Universe II™

Manual Addendum

Document Number: 8091142_AD001_05

Release Date: September 2001

- Page Number: App B-13

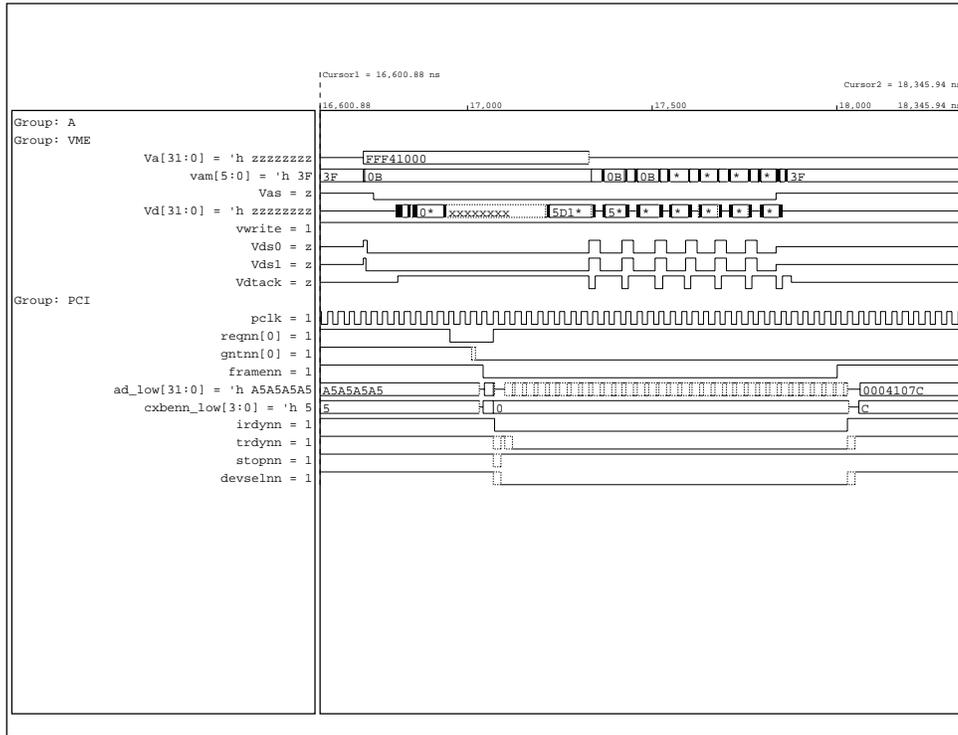
Errata Description: Figure B.11: Pre-fetched Read Cycle - Universe II as VME Slave is incorrect.

Corrective Action: Replace the existing figure with the following:
